Ref. LCR 79-06

CYCLE 2 RELOAD ANALYSIS  
FACILITY OPERATING LICENSE DPR-70  
UNIT NO. 1  
SALEM GENERATING STATION  
DOCKET NO. 50-272

PUBLIC SERVICE ELECTRIC AND GAS COMPANY  
FACILITY OPERATING LICENSE NO. DPR-70  
NO. 1 UNIT  
SALEM GENERATING STATION

FIGURE 3.2-2

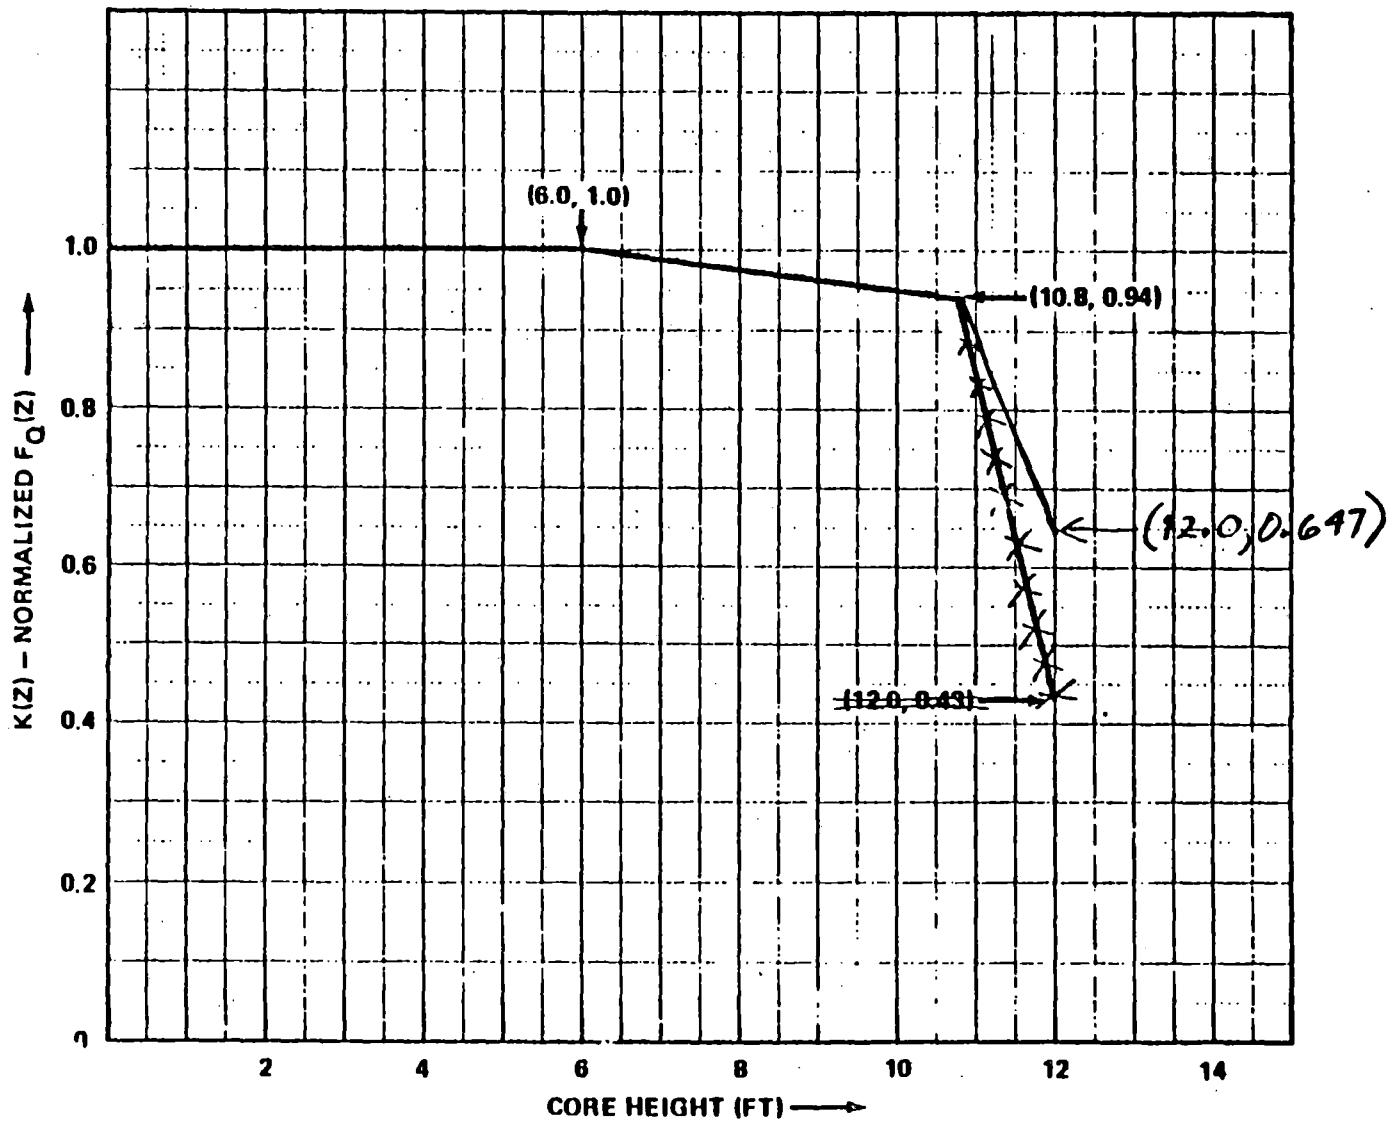
1. Revise the third line segment of the  $K(Z)$  curve (figure 3.2-2).
2. Revise the  $F_{xy}$  limits as contained in this section of the technical specifications.

1. This revision is necessary due to violation of the  $F_Q(Z)$  limits during cycle 2 operation with the current third line segment of the  $K(Z)$  curve.
2. Recent analyses for Westinghouse plants which undertake reload cycle operations with an  $F_{xy}$  technical specification show the need to revise these limits upward for other than cycle 1 operation. Salem No. 1 is one of the first Westinghouse units with an  $F_{xy}$  limit to reload and a revision in this limit is required to avoid exceeding  $F_{xy}$  limits during the second and subsequent cycles.

1. The revised  $K(Z)$  curve has been used in the design of cycle 2. Analysis of cycle 2 is expected to verify the validity of the revised  $K(Z)$  curve for cycle 2 operation. Because of this change the small break LOCA analysis must be redone. This analysis, using currently approved Westinghouse analysis models will be completed in March 1979, and is expected to confirm the validity of the revised  $K(Z)$  curve. The results of this reanalysis will be submitted after it is completed. If the results are as anticipated the LOCA analysis for cycle 2 will be confirmed using the revised  $K(Z)$  curve and therefore, this change will not constitute an unreviewed safety question. The revised third line segment will be reverified for each reload beyond cycle 2.
2.  $F_Q(Z)$ , which is the primary power distribution parameter in the Technical Specifications for LOCA protection, is deter-

FIGURE 3.2-3  
ROD BOW PENALTY AS A FUNCTION OF BURNUP

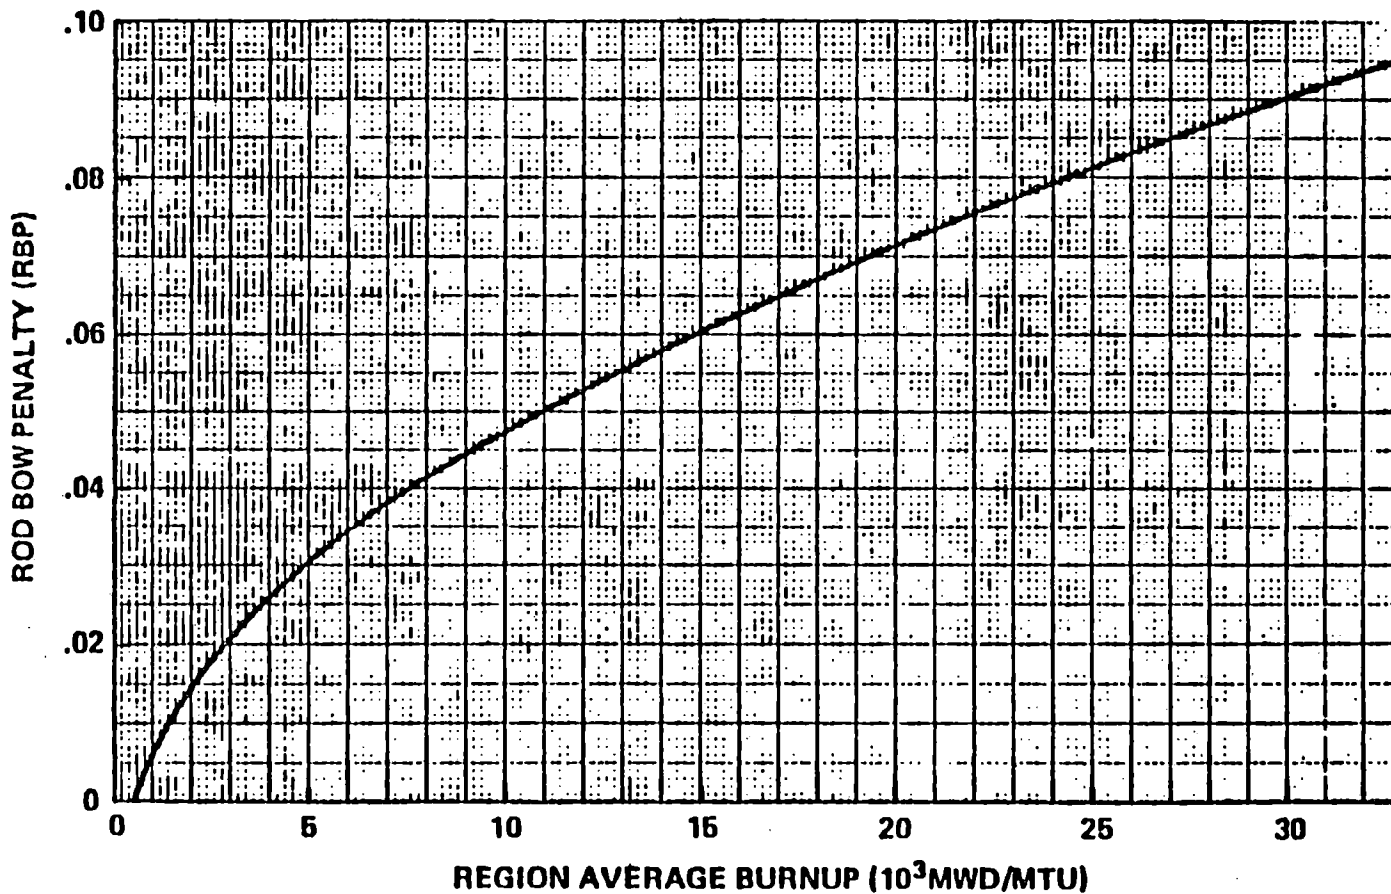
Revise the  $F_{\Delta H}^N$  technical specification, incorporating the rod bow penalty curve that is currently approved by the NRC. This curve has been documented as having generic application for Westinghouse 17 x 17 plants in a Westinghouse submittal, NS-TMA-1760, "Fuel Rod Bowing", T. M. Anderson (Westinghouse) to J. F. Stolz (NRC), dated April 19, 1978. This change would result in a reduction of the current rod bow penalty applied to Salem No. 1.

To reduce the rod bow penalty (especially for second cycle fuel) to accommodate expected  $F_{\Delta H}^N$  values that will be encountered at rated thermal power during cycle 2 operation.

$RBP = \text{Rod Bow Penalty as shown in figure 3.2-3}$
